TO:MR. DAVID CROXTON
HW-106

FROM:ROBERT FARRELL

SUBJECT:BURLINGTON, PIER 91, OCTOBER, 1993 RFI REVIEW

Summary--The investigation into the shallower aquifer seems to be adequately done so that a corrective action program can be developed. The RFI for the deeper ground water does not appear to have been adequately completed and numerous questions still remain to be answered.

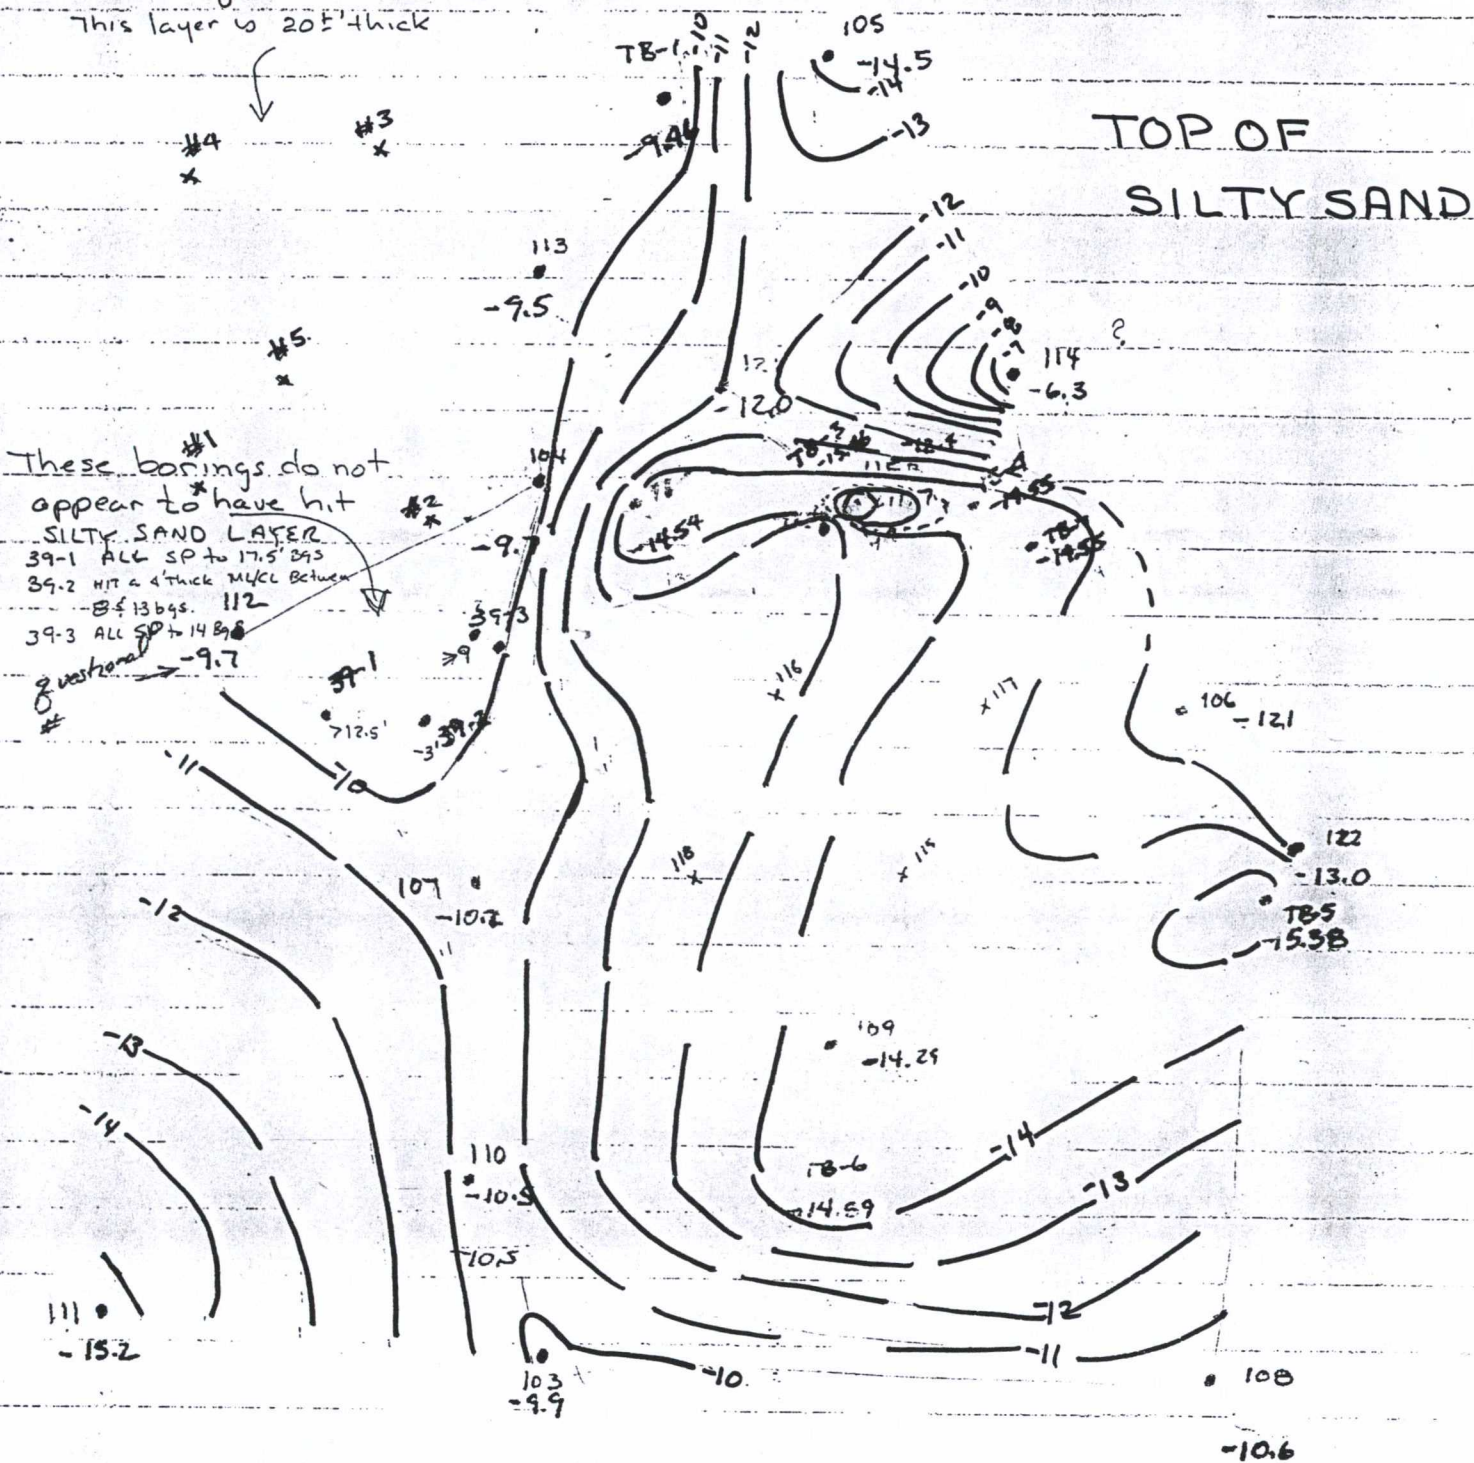
The data contained in the site characterization report indicates there are several large holes in the monitoring program for the deeper aquifer. There need to be deep monitoring wells between 104B and 103B on the west side. The complexity of the lower aquifer suggest there should be two wells to cover this gap. On the east side there is a large gap between 122B and 108B. There needs to be a deep well between 103B and 108B to cover this gap at the south end of the site. Nothing? is known about the distribution of chemicals in the deep aquifer directly under the facility. There need to be two deep monitoring wells located between 115B in the north and the future location of a deep monitoring well at about W-10 on the south end of the site. After these wells are installed, the tidal study needs to be repeated with the shortcomings of the earlier one corrected. The most glaring shortcomings are the need for shorter intervals of water level measurements and for the ocean tidal responses to be measured at the closest place to the site. * Not BEZ site limited show me where! why

well here even tho upgradient?

FIGURE 1

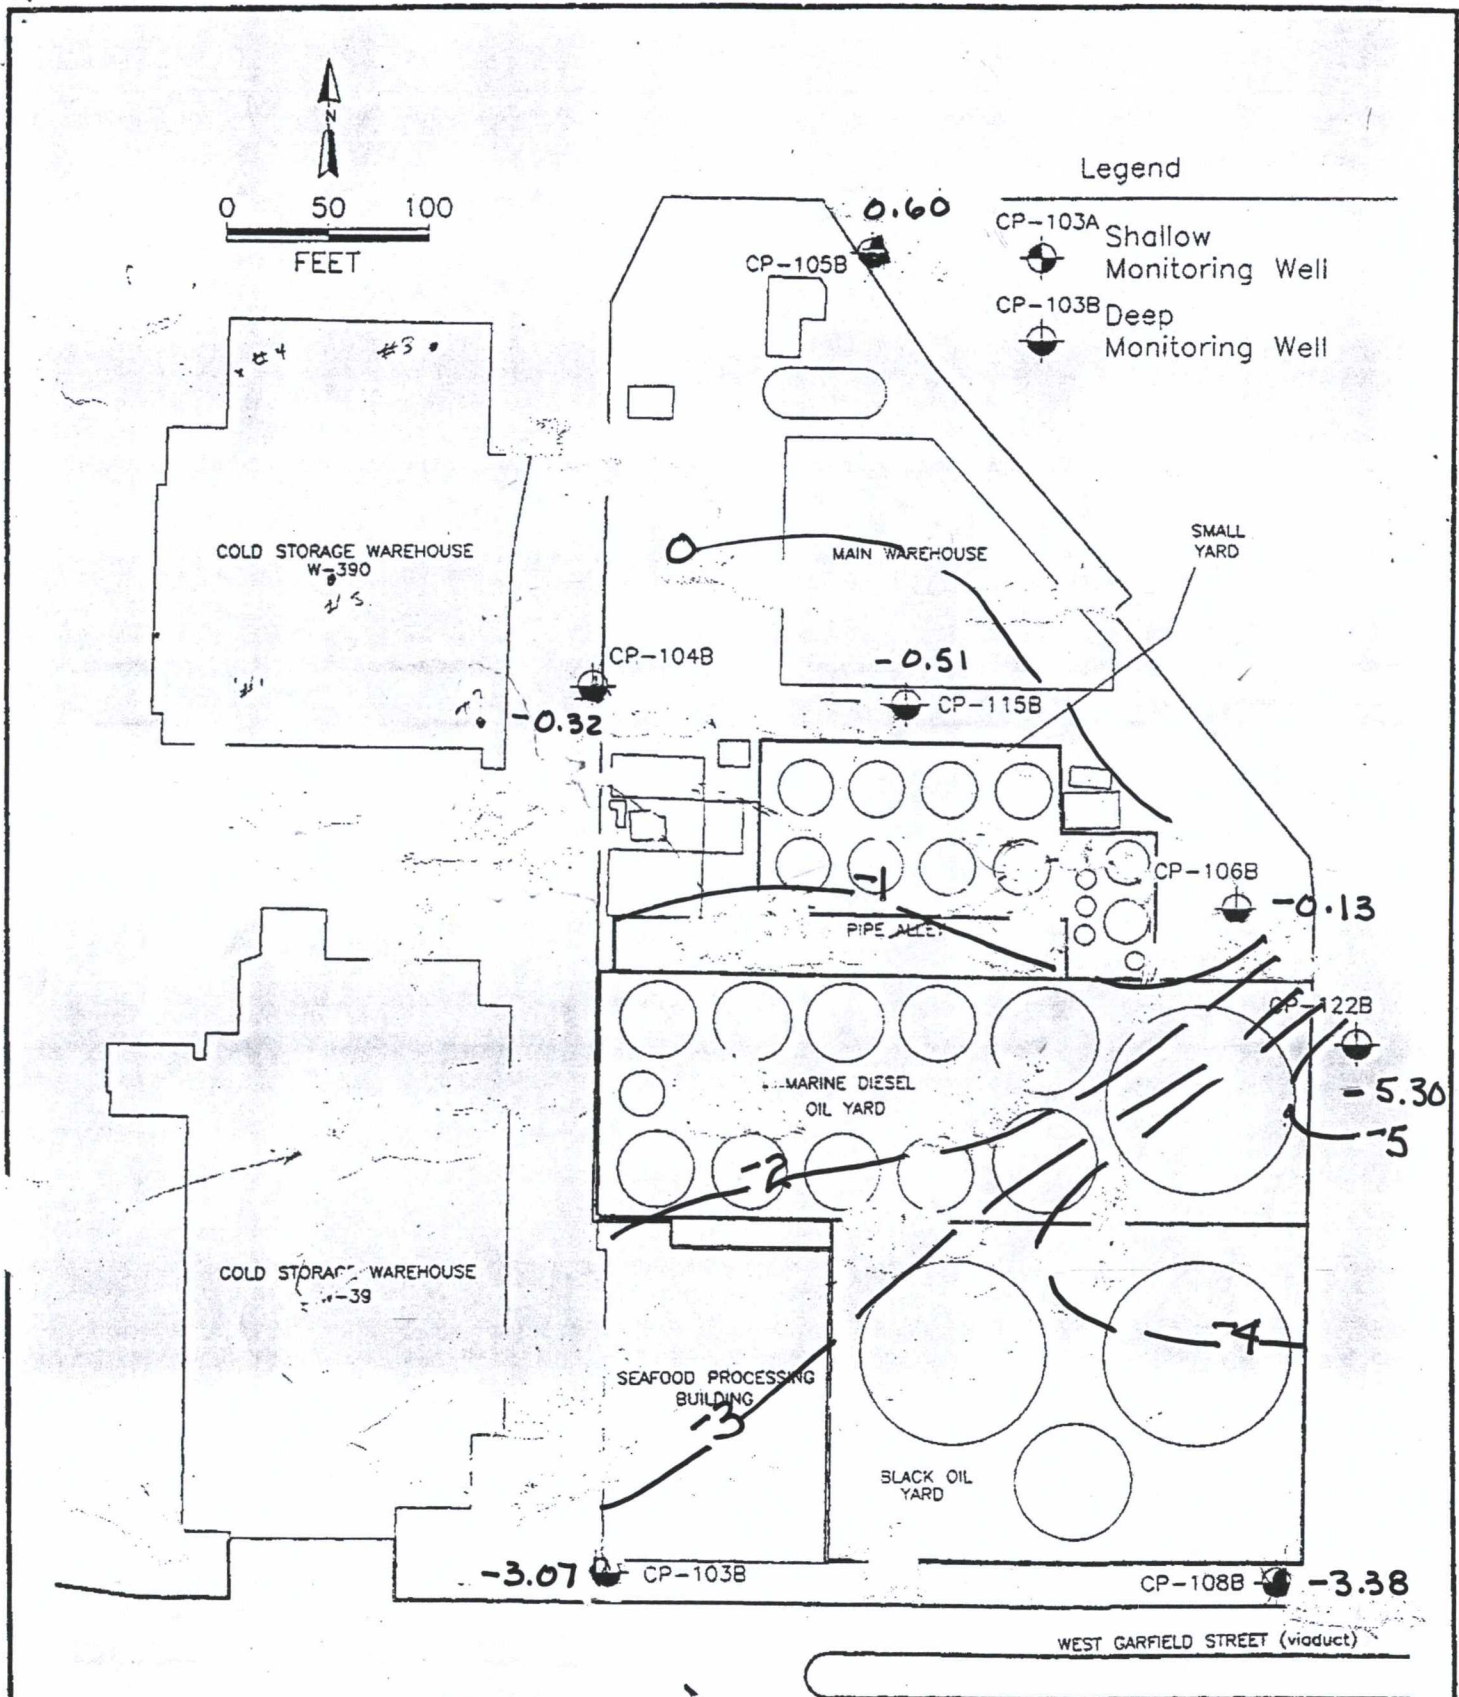
Figure 4-4 presents BEI's interpretation of the shape of the top of the sandy silt layer. Within the text this layer is normally referred to as a silty sand layer (SM vs a ML classification). Much information has been left off this map. None of the TB borings have been included. The information contained in the MW-39 well boring logs were not included suggesting that there is no silt sand layer at the depth suggested on figure 4-4 of between elevation -9 and -10 feet. Boring 112 is of questionable value because it was only drilled one foot into a silt layer. The data for boring 111 indicates that the silty sand layer is encountered at -15.2 feet rather than the indicated -21.0 on figure 4.4. At 122 the log suggests an elevation of -15.4 against -13.0 indicated on figure 4-4. For well 106 the boring log indicates the top of silty sand as -12.1 while the map indicates an elevation of -9.8. Well 121 is -12 on the log and -11.3 on the map. Well 105 is -14.5 on the log and -12.1 on the map. Well 109 is -15.3 on the map and is -14.3 on the log. The log for Well 115A indicates an elevation of -12.4 whereas the log for well 115B indicates the top of the silty sand is at -11.7. These changes have been made on the attached figure 1. The TB boring data has also been included on attached Figure 1. Figure 1 would suggest a far busier surface than does BEI's figure 4-4. When contoured with all the available data, it is not clear that the data actually represents a continuous surface or not. The data from the 39 wells and building 390 borings would suggest that the surface is discontinuous.

1987 REPORT (GeoEngineers Inc.)
 Borings for City Ice & Cold Storage Company
 suggest SS Layer starts @ 7'-6" below
 ground surface (before building)
 & Elevations of -2' to -3' is suggested!
 This layer is 20' thick

VERY SHALLOW SS. ELEVATION
 ARE SUGGESTED BY
 LOGS for 116, 117, 118, 119
 it is possible this SS. Layer
 extends to 115A

ADDED TB-5
 TB-6
 TB-3
 TB-4
 TB-2
 TB-1
 114
 115A

CHANGED 106B from -9.9 to -12.1
 105B from -12.1 to -14.5
 111 from -21.0 to -15.2
 109 from -15.3 to -14.29

QUESTIONABLE DATA 112 (ONLY 1' S.S. penetrated)

39-1, 39-2, 39-3 DID NOT ENCOUNTER SS. AT DEPTHS BELOW CP112, 104B, 107.

These flow directions are not significantly different than the time average water levels shown on figure 4-21 nor the snapshots of deep aquifer flow shown on figure 4-8 for March, 1993 and figure 4-9 for July, 1993. The suggestion would be that taking single water level measurements for the deep wells provides an accurate picture of the flow relationships in the deep aquifer. But the comparison of the heads shown on figure 4-8 and 4-9 of the contoured heads does not agree with the heads presented on tables

in appendix G. In particular 122B in the tables has an elevation of -5.3 in March, 1993 and is shown on figure 4-8 as -0.54. In July, 1993 the table indicates the water elevation should be -5.17 but figure 4-9 indicates the water elevation is -0.44. No explanation is provided in the report for these discrepancies. When the maps are contoured with the water levels from the tables in appendix G (attached figures 2 and 3) ground water flow in the deep aquifer becomes strongly east to northeast in the area of 122B on both dates.

= change report

HYDROGEOLOGIC CROSS SECTION

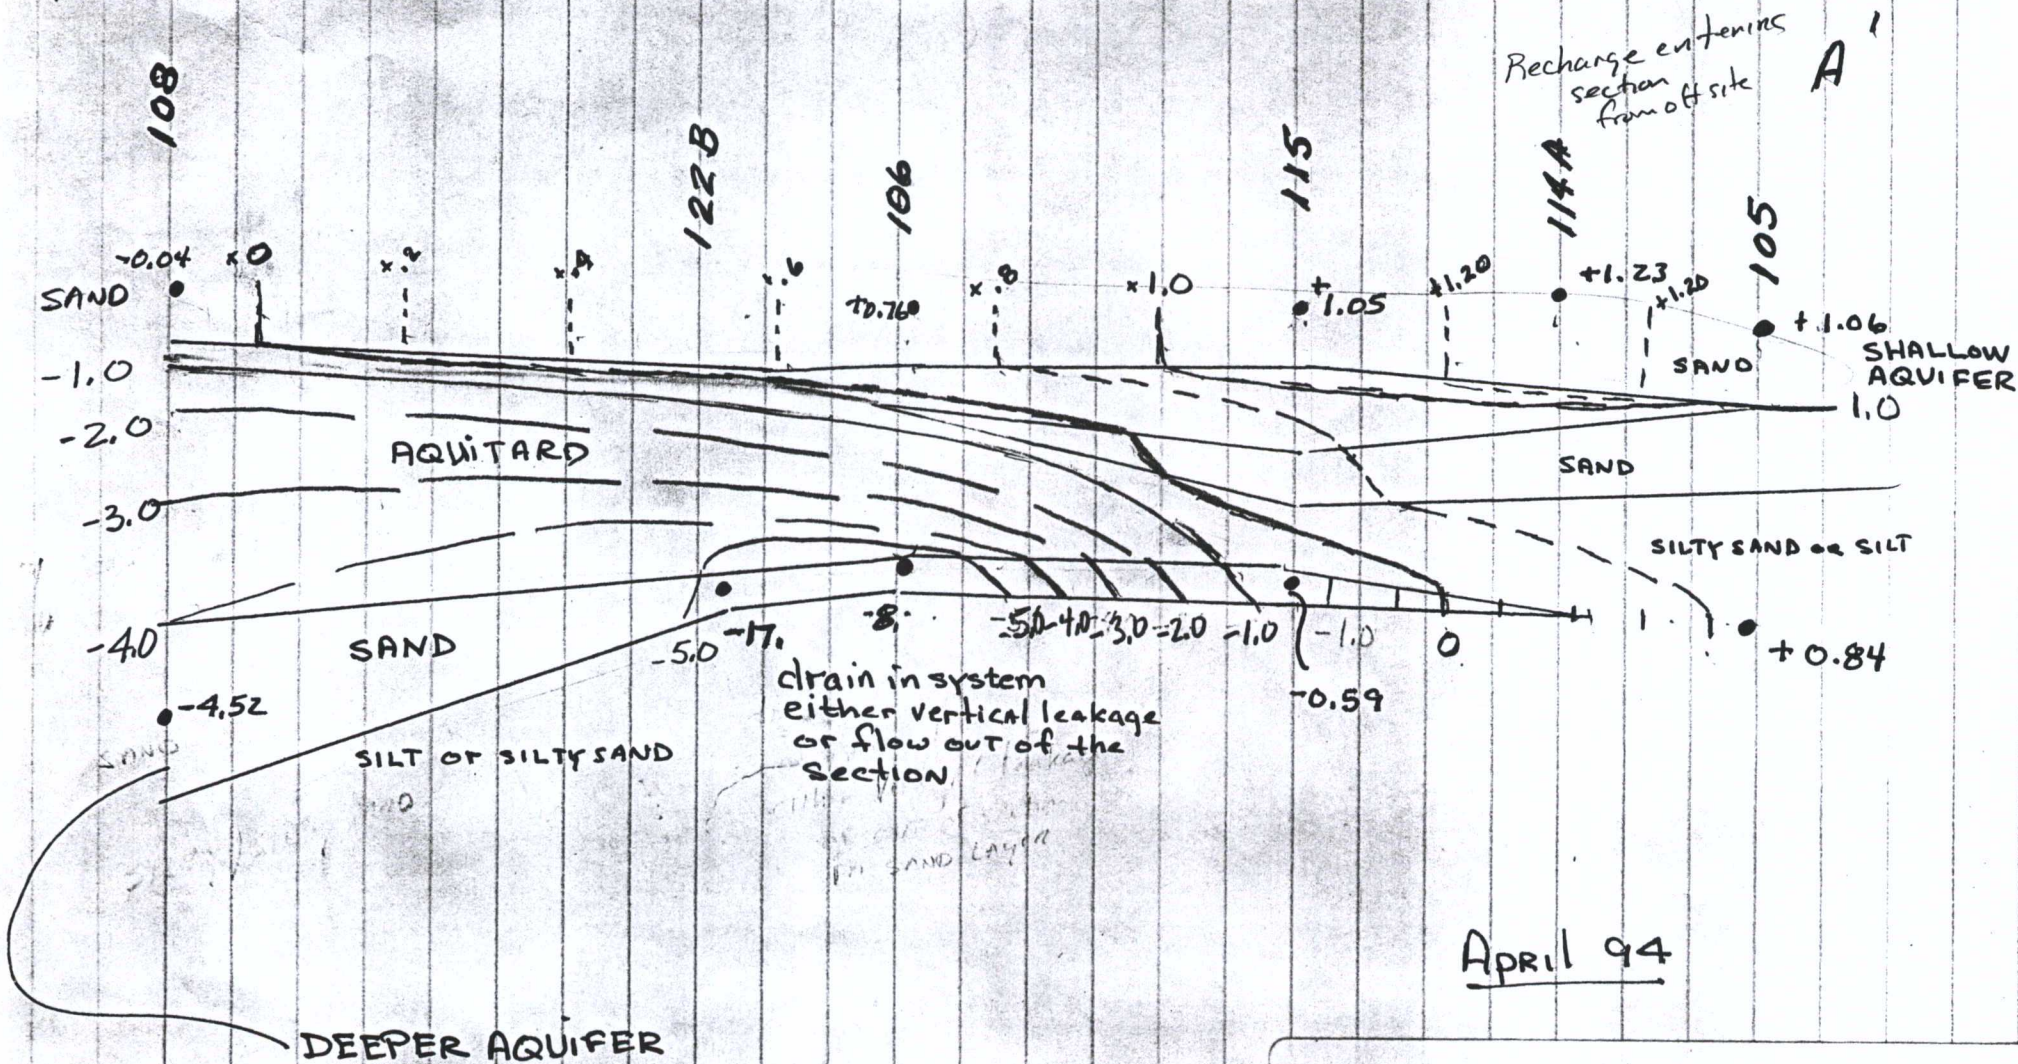
The K presented in the RFI suggest a ratio of 1266/1/23 between the upper sand aquifer, silty sand aquitard, and lower sand aquifer. These ratios are sufficient so ground water flow in the aquitard will be nearly perpendicular to its upper and lower contacts with the sand aquifers above and below the aquitard. Vertical hydrogeologic cross sections were drawn for April, May, and July, 1993 data (shown on attached figures 4, 5, and 6). The cross section, from south to north, go through wells 108 A and B, 122B, 106 A and B, 115 A and B, 114A, and 105 A and B. The three cross sections have similar patterns of ground water flow. The ground water flow in the upper aquifer is nearly horizontal, the flow in the aquitard is strongly downward, and the flow in the lower sand aquifer is generally horizontal toward 122B. It is not clear if the flow around 122B indicates further vertical flow or if the flow is into or out of the cross sections. The attached horizontal contour maps for the deeper aquifer (figures 2 and 3) suggest flow should be out of the section at 122B.

The hydrogeologic cross sections are consistent with the ratios of K between the observed layering and the K values presented in the report. The cross sections confirm that the silty sand layer acts as an aquitard between the shallow and deeper sand layers. The sections do not aid in understanding the lack of response of 122B and 106B during the tidal monitoring. The cross sections raise some questions about the ground water flow in the area of 122B and 106B. These wells are acting entirely different than the other deep sand wells and there appears to be a channeling of ground water flow to the east. As has been suggested in the past, there is a suggestion that ground water pumping or lowering is occurring somewhere in the vicinity of the site.
